HISTORIC DISTRICT COMMISSION

September 7, 2023 - 6:00PM
Saugatuck City Hall
102 Butler St. Saugatuck, MI 49453

MEMORANDUM

FENCE
PANELS
TO REMOVE

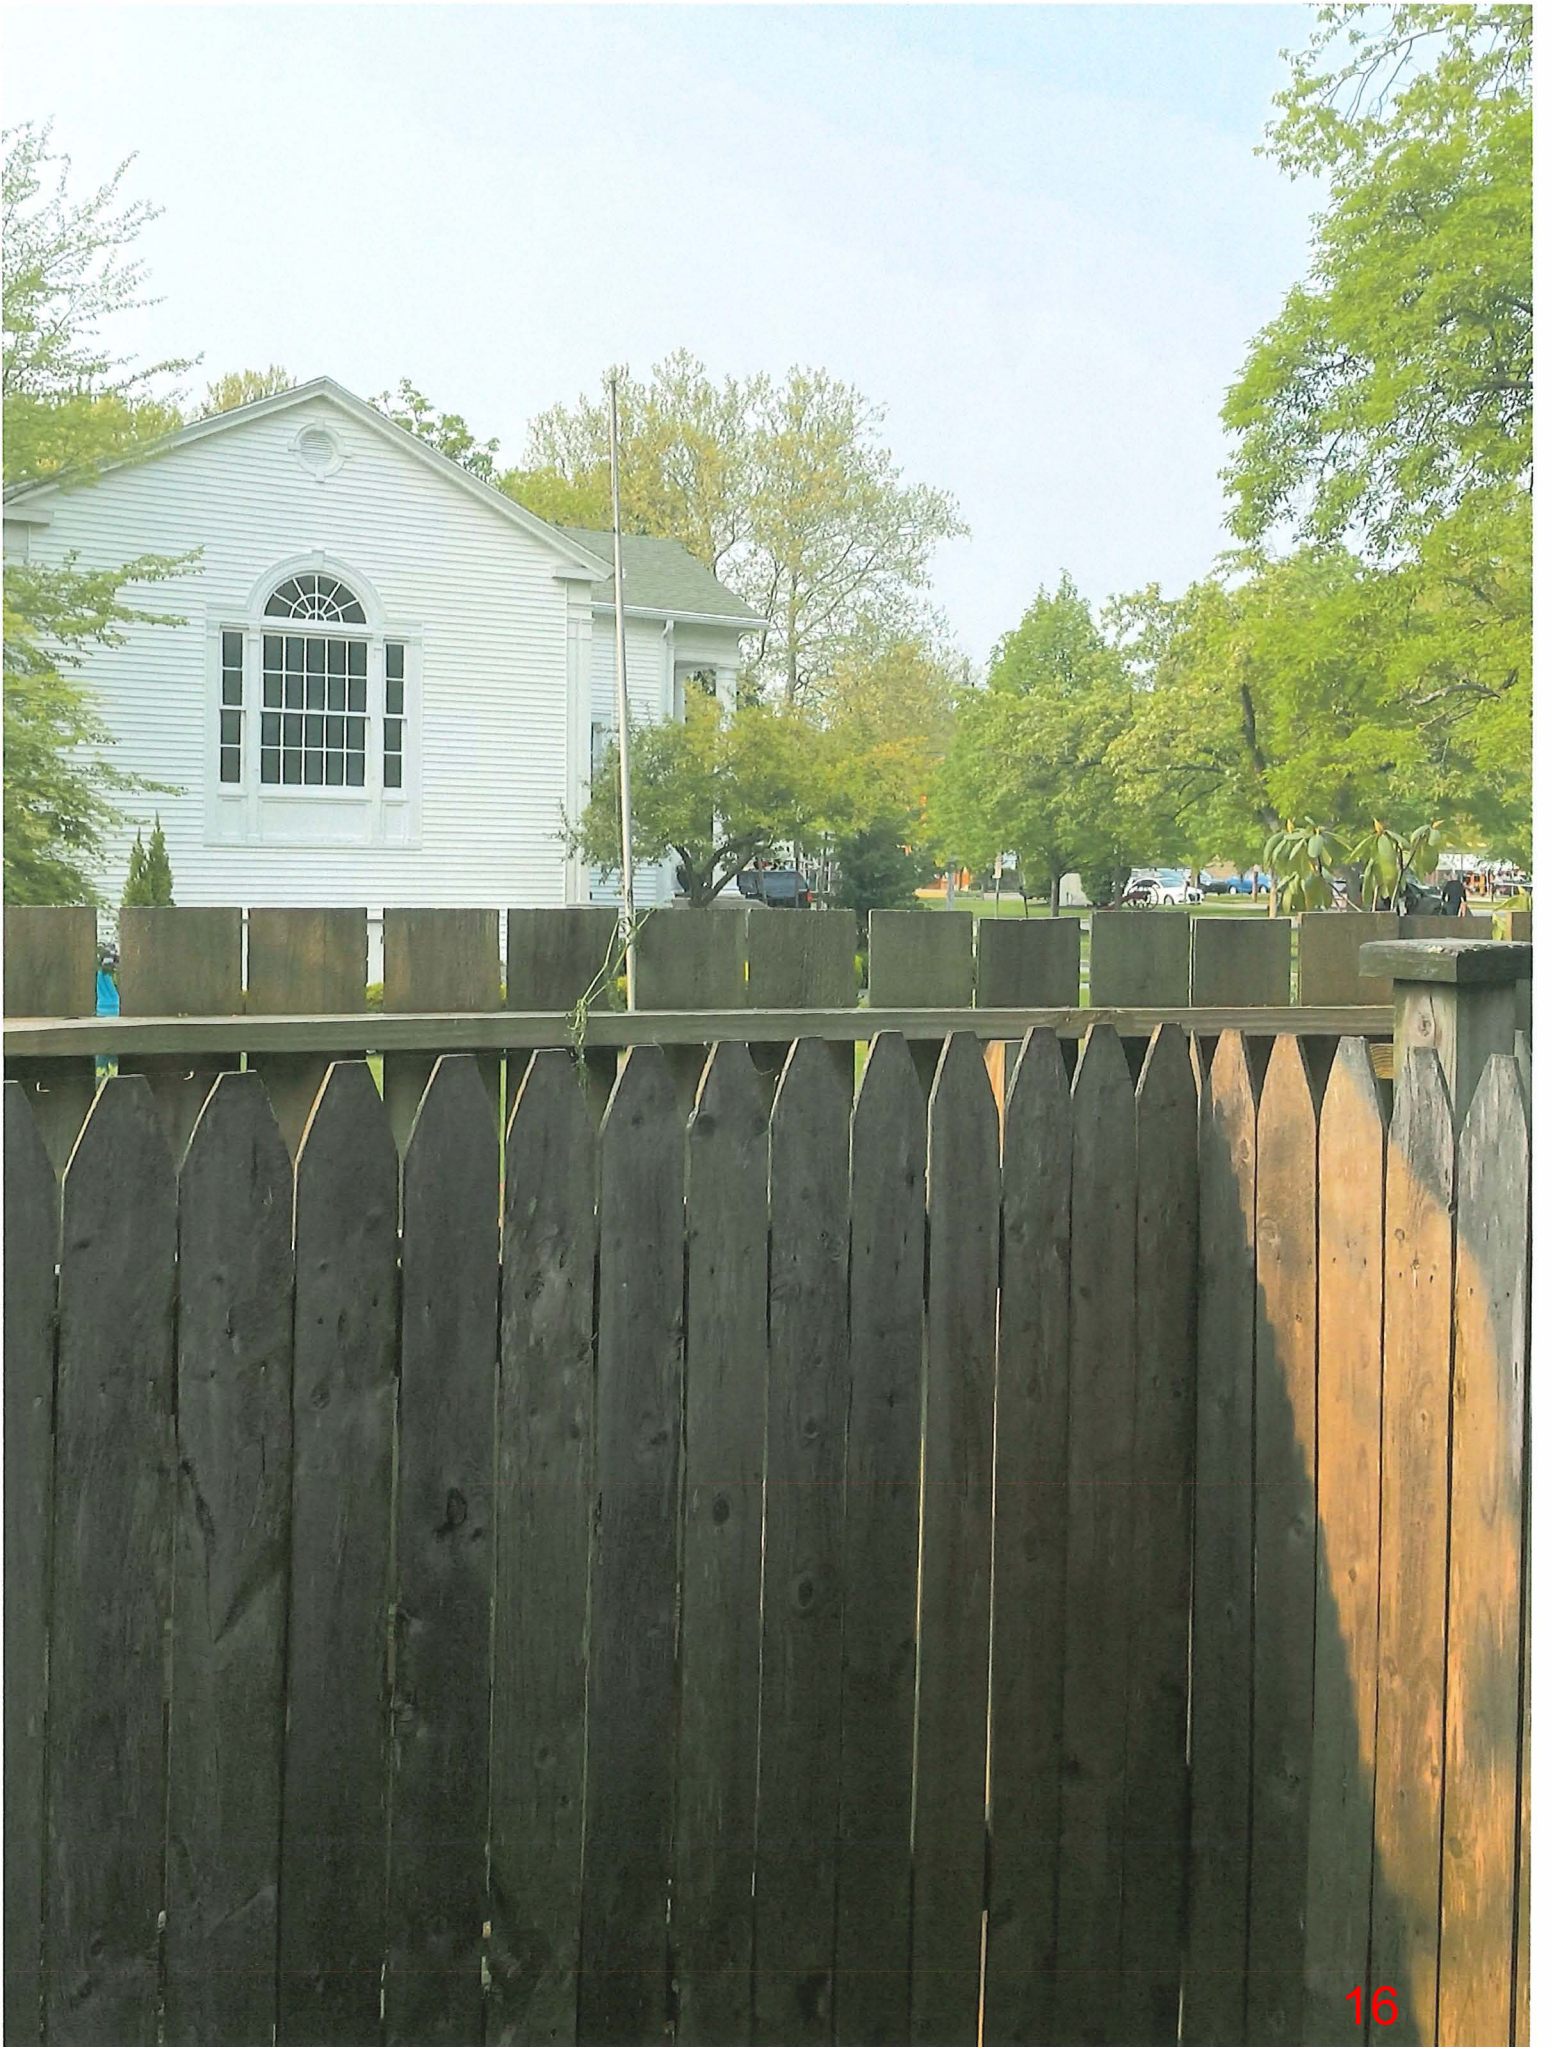
Comments: The survey provided by the applicant, which supplements the application, is not clear on the fence location. However, a survey provided for ZBA review shows the new fence replacement from the driveway gate along the north property line to the northeast corner of the lot, for the entire length of the eastern rear property line, and along the south property line up to the southeast corner of the home (highlights added).

The applicant should clarify the picket width and color.

Need Approval:
Flush Paver Patio is not within 3' to any side or rear property line.

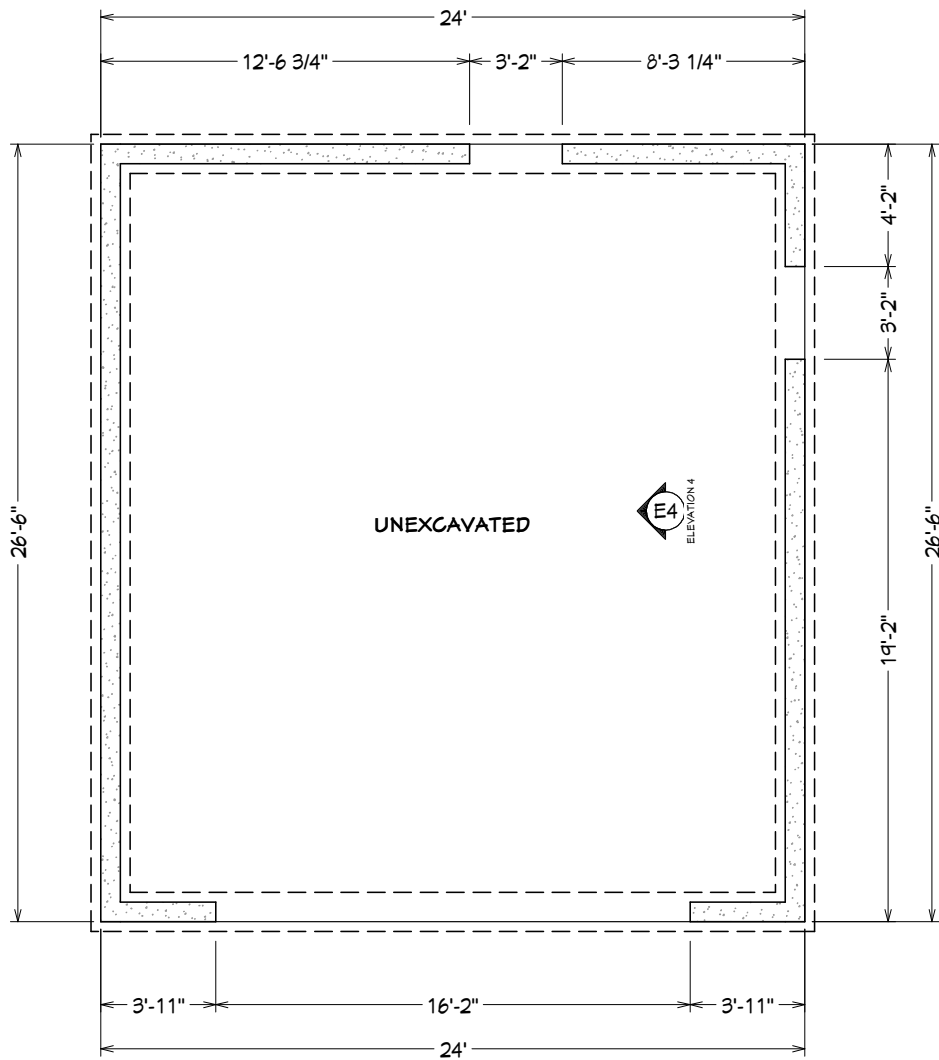
6. Portion of the deck wasn't constructed. Patio was constructed

***Per Historic District Guidelines Section IV The Land and Site Improvements, paragraph D Patios, Decks, Garden Structures, item 1 Rear Yard Patios and Decks. Elevated platforms and flush patios may be allowed in rear yards only, unless special circumstances exist.*

Dotted line is fence to
hide garbage cans

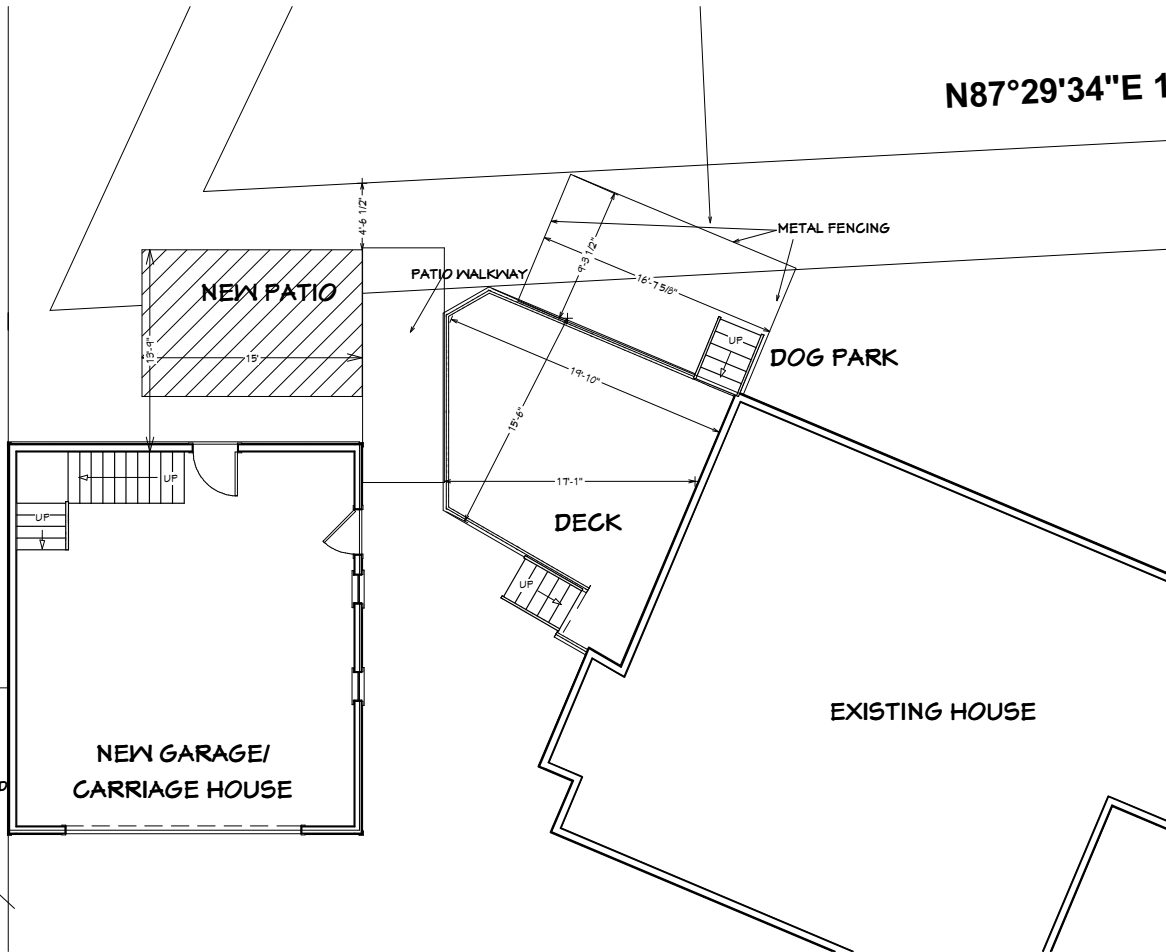
Need approval for concrete pad to store garbage can and recycling bin on side of garage and privacy fence for concrete pad on side of garage (to hide garbage cans from neighbors front yard)

*****Per Historic District Guidelines Section IV The Land and Site Improvements, paragraph C Fences, item 2 Front and Side. Front and side yard fences should not impede clear vision at intersections or driveways, as they could sacrifice safety as well as historical appropriateness. Item 4 Height of Fences: Height should be two and six feet maximum height, with a maximum height of 3 feet for front yard fences. Materials should be wood, wrought iron, or other historic materials Styles may include picket and wood privacy fences, with tops trimmed with horizontal boards or simple dog-ear detail.***
